Memorandum

RE: ASSESSING THE DECEMBER 2014 ERCOT REPORT ON ENVIRONMENTAL REGULATIONS

Figure 1. Texas CPP Rate Targets (lbs CO₂/MWh) under proposed and final rule

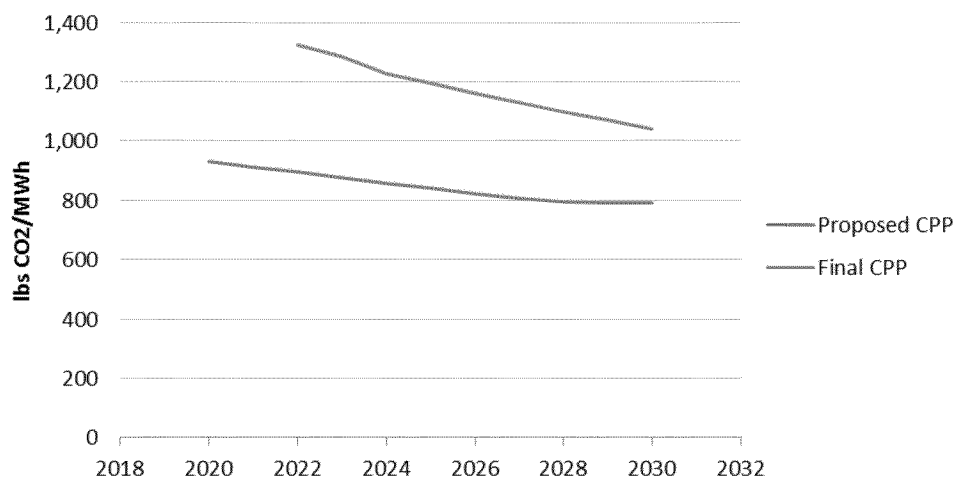
There are a number of notable differences between the proposed Clean Power Plan rule modeled in the ERCOT study and the finalized rule of August 2015, each which Synapse believes will only lessen any reliability challenges ERCOT cites.⁷

- First, the compliance period for the CPP has shifted, and the first year of compliance is now 2022 instead of 2020. While there are incentives for early actions, this change should largely alleviate concerns about reserve margin size; Texas will now have an additional two years to have energy efficiency and other measures materialize before compliance begins.
- Second, ERCOT’s requirements under the final CPP are substantially less stringent than under the proposed rule. As shown in Figure 1, below, the compliance requirement is over 40% less stringent at start of compliance, and over 30% less stringent in the final compliance year. One would expect that this change in requirement will likely result in fewer economic coal unit retirements.
